# COMMUNITY DEVELOPMENT DEPARTMENT REPORT

HEARING DATE: 3/6/2025  
TO: Planning & Zoning Commission  
FROM: Sonya Allen, Associate Planner  
208-884-5533  
sallen@meridiancity.org

APPLICANT: Brighton Corporation

SUBJECT: [H-2024-0037](#)  
Pollard North – MDA, PP, RZ

G. Landscape Plan (dated: 7/25/24 12/23/2024 1/28/2025) - REVISED

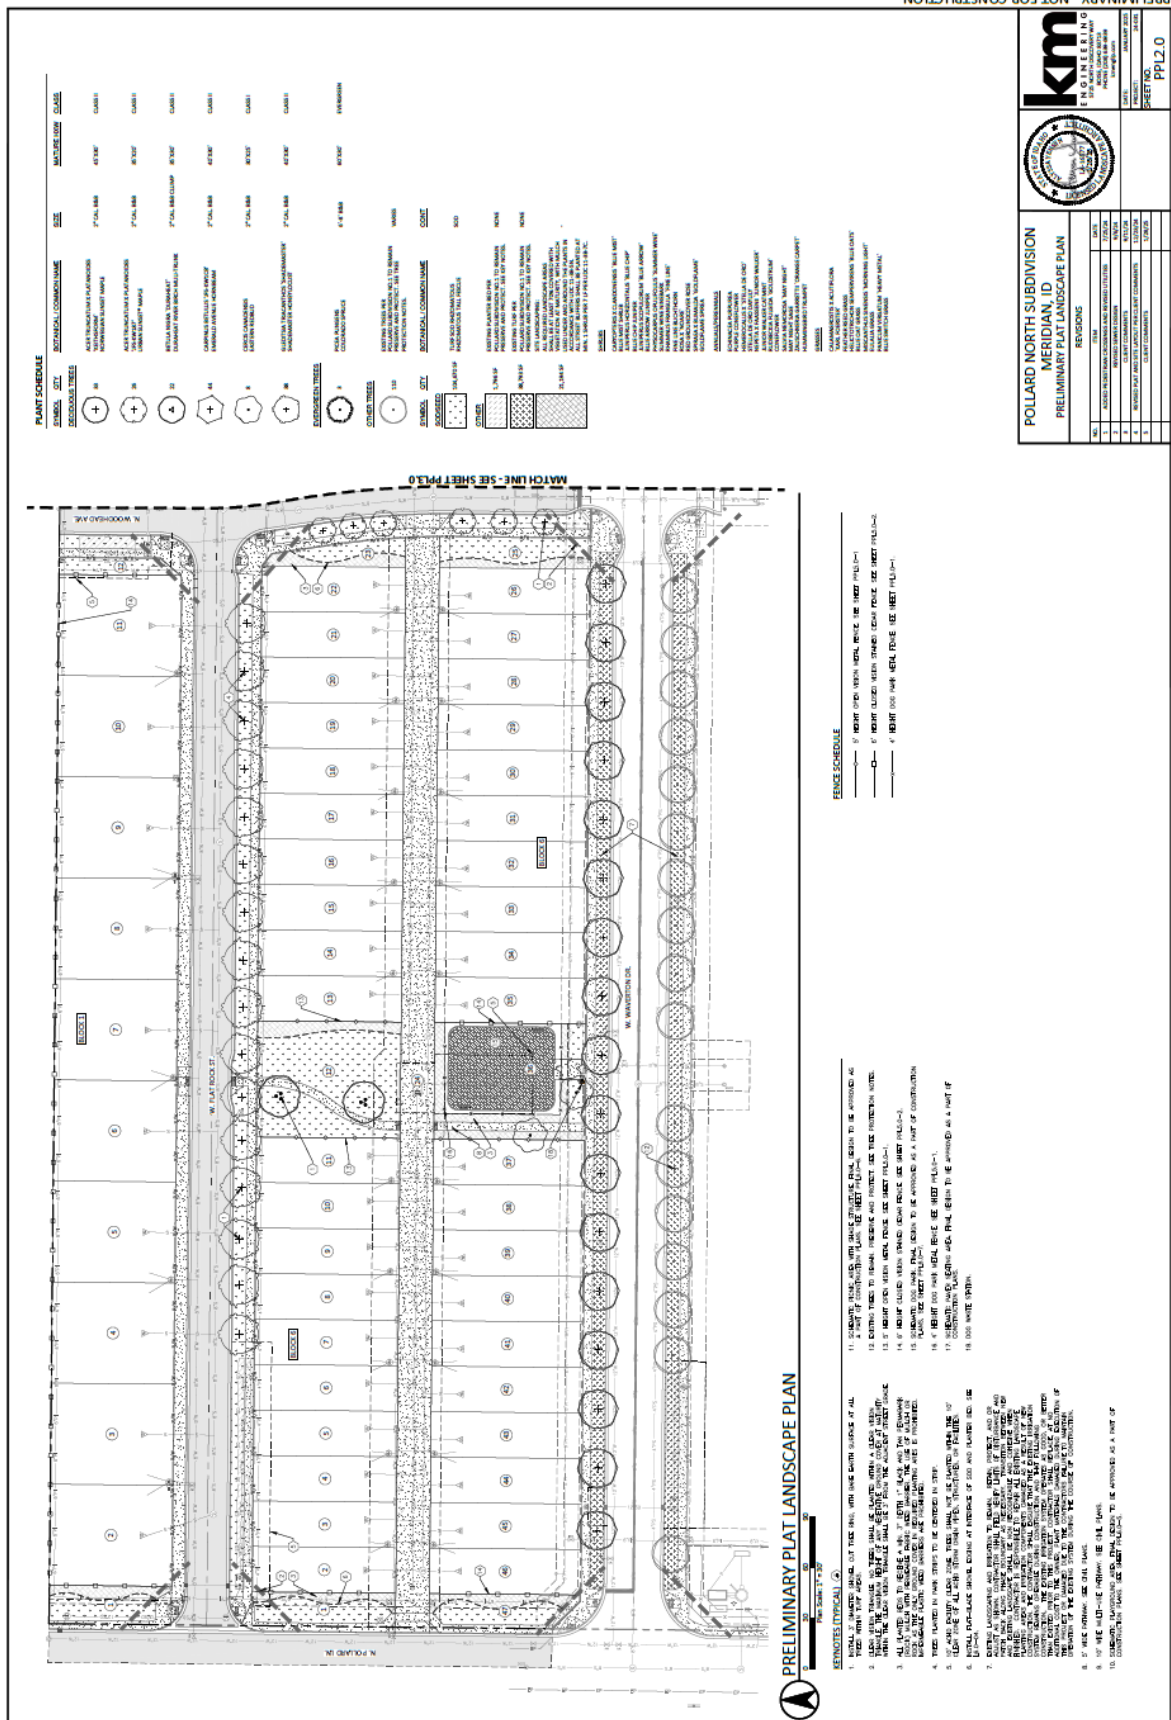
The landscape plan depicts 5-foot tall open vision metal fencing and 6-foot tall closed vision stained cedar fencing on the shared property line of some building and common lots. **The developer is responsible for constructing fences abutting all pathways and common open space lots to distinguish common from private areas. Fencing should be depicted on a revised**

**The pathways along the east and west sides of Lot 14, Block 5 abut the residential property lines and don't have the required 5-feet of landscaping on both sides of the pathway as set forth in UDC 11-3B-12C. The landscape plan should be revised to comply with these standards; or, a request for alternative compliance may be submitted to this standard as set forth in UDC 11-5B-5.**

- ii. Depict fencing abutting pathways and common open space lots to distinguish common from private areas as set forth in UDC 11-3A-7A.7; or, submit a request for alternative compliance to this standard.

- iii. Depict a minimum 5-foot wide landscape strip along both sides of the pathways located along the east and west sides of Lot ~~45~~ 14, Block 5 with landscaping in accord with the standards listed in UDC 11-3B-12C; or, submit a request for alternative compliance to this standard as set forth in UDC 11-5B-5.
